Access Compliance Report Public Rights-of-Way (Curb Ramps)

Main Street: CEDARWOOD_AVE Cross Street: HARHAY_AVE Location: NE

ADA ID: RPRK211005174202 Ramp Type: Type 1 - Perpendicular Diagonal Initial Pass/Fail: Fail Overall Compliance: No Severity Score: 32

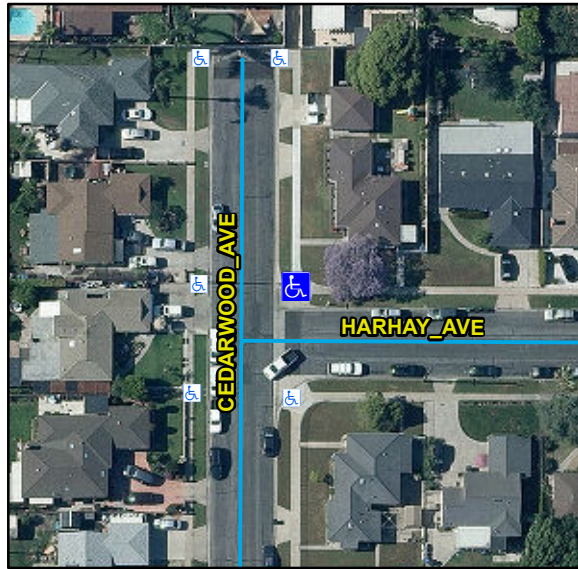
Compliance	Description	Data	Compliance	Description	Data
N/A	Ramp Length (in)	96	N/A	Flare Type LT	
Yes	Ramp Width (in)	48			N/A
No	Ramp Run Slope (%)	12.1	N/A	Flare Slope LT (%)	N/A
No	Ramp Cross Slope (%)	3.2	N/A	Flare Traversable LT	N/A
N/A	Landing Present	N/A	N/A	Flare Type RT	
N/A	Landing Length (in)	N/A			N/A
N/A	Landing Width (in)	N/A	N/A	Flare Slope RT (%)	N/A
N/A	Landing Run Slope (%)	N/A	N/A	Flare Traversable RT	N/A
N/A	Landing Cross Slope (%)	N/A	N/A	DWS Provided	N/A
N/A	Landing Movement Obstructed?	N/A	N/A	DWS Contrast	N/A
	Landing Movement Type	N/A	N/A	DWS Length (in)	N/A
N/A	Landing Shared	N/A	N/A	DWS Full Width	N/A
N/A	Clear Space	Yes	N/A	DWS Offset Left (in)	N/A
N/A	Clear Space To Crosswalk (in)	N/A	N/A	DWS Offset Right (in)	N/A
N/A	Marked Crosswalk 1	No	N/A	Marked Crosswalk 2	No
	Crossing 1 Direction	W		Crossing 2 Direction	S
	Marked Crosswalk 1 Width (in)	N/A		Marked Crosswalk 2 Width (in)	N/A

N/A	Ramp Inside Crosswalk 1	N/A	Yes	Ramp Inside Crosswalk 2	N/A
	Crossing 1 Slope (%)	8		Crossing 2 Slope (%)	0.4
	Crossing 1 Cross Slope (%)	2.3		Crossing 2 Cross Slope (%)	0.7
N/A	Gutter Ponding	N/A	No	Curb Slope	9.7
Yes	Gutter Lip Height (in)	0		Road Run Slope (%)	1.5
N/A	Gutter Run Slope (%)	N/A		Road Cross Slope (%)	5.5
N/A	Gutter Cross Slope (%)	N/A			
Yes	Overall Surface Condition: Acceptable		Yes	Perp Joint Present	Yes
	Cross Gutter Present?	Yes		Spandrel Present?	Yes
	Replace Cross Gutter?	No		Replace Spandrel?	No

Remove & Replace Curb Ramp With Two New Directional Ramps or Equivalent.

R304.2.2, R304.5.3, STD 1115
